ADDENDUM NO. 03
TO
SPECIFICATIONS AND CONTRACT DOCUMENTS FOR
INVITATION TO BID
PURCHASE OF SIX (6) HYBRID ELECTRIC
RTG CRANES
JPA CONTRACT NO. EQ-1933

**PURCHASE OF SIX (6) HYBRID ELECTRIC RTG CRANES
JPA CONTRACT NO. EQ-1933
ADDENDUM NO. 03
RESPONSE TO QUESTIONS**

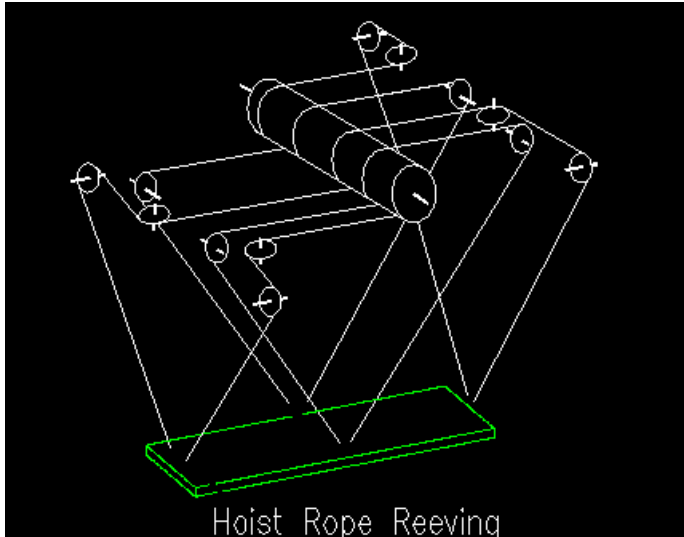
4. A4-1 4.03 span 7+1, height 1 over 6; Please clarify the exact value for span and hoist height.

ANSWER: Minimum Span (inside clear width): 81'3" (24.77m); Minimum hoist height (ground to bottom of spreader): 59'3" (18.06m).
